## MEMORANDUM

**Subject** 500 Harvard Street Traffic Peer Review

**Figure 1 – Site Location Map (Source: VAI Memo)**

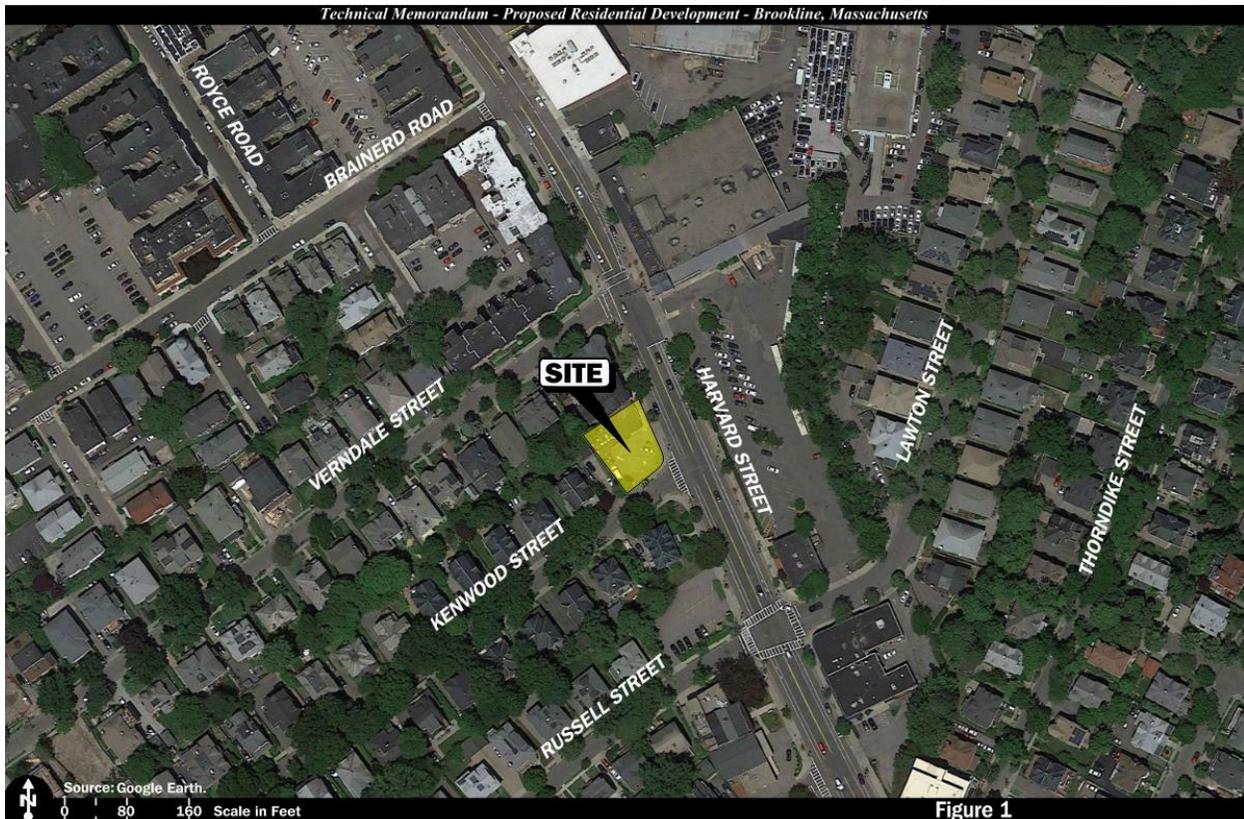
Kenwood Street is a residential, local one-way roadway that runs in a general westbound direction. Coolidge Park is located on the southern side of the roadway and contains tennis and basketball courts, a playground, walkways, and greenspace. The roadway contains a speed hump and a posted 15 mile per hour (mph) speed limit. Through discussions with the Town of Brookline, the Town Transportation Administrator indicated that the speed hump was installed due to the proximity to Coolidge Park. At that time, the speed limit on Kenwood Street was 30 mph and speeding was not cited as a reason for installing the speed hump.

Kenwood Street intersects Columbia Street on its east side. Columbia Street is also a residential, local roadway and contains bi-directional travel in a general northbound-southbound direction. In the northbound direction, the roadway has been cut-off between Verndale Street and Brainerd Road due to an issue with cut-through traffic in the past. In the southbound direction, the roadway curves and intersects Harvard Street on its west side, approximately 400 feet south of the Kenwood Street intersection. As such, there is no direct outlet from Columbia Street to points north or south of the project.

The proposed project is located on the northwest corner of the intersection of Harvard Street and Kenwood Street. As the existing curb cut on Harvard Street is proposed to be closed, all vehicles exiting the site will have to travel westbound along Kenwood Street away from Harvard Street, along Columbia Street, and then along one of the other residential roadways to circulate back to Harvard Street to access points to the north and south of the project area. (The trip distribution for the proposed development described in the Trip Distribution and Assignment section indicates 50% in

each direction.) Despite being located on the corner of Harvard Street, residents will have to travel an inconvenient route through a residential neighborhood with slow speeds for as long as 2,600 feet to access Harvard Street.

VAI did not study the roadways in the surrounding neighborhood despite the proposed driveway location requiring vehicles to exit onto a one-way road through the neighborhood. EP recommends considerations be made for site traffic impacts to safety for the cut-through route of exiting site traffic, as discussed in detail in the “Recommendations and Conclusions” section at the end of this memo.
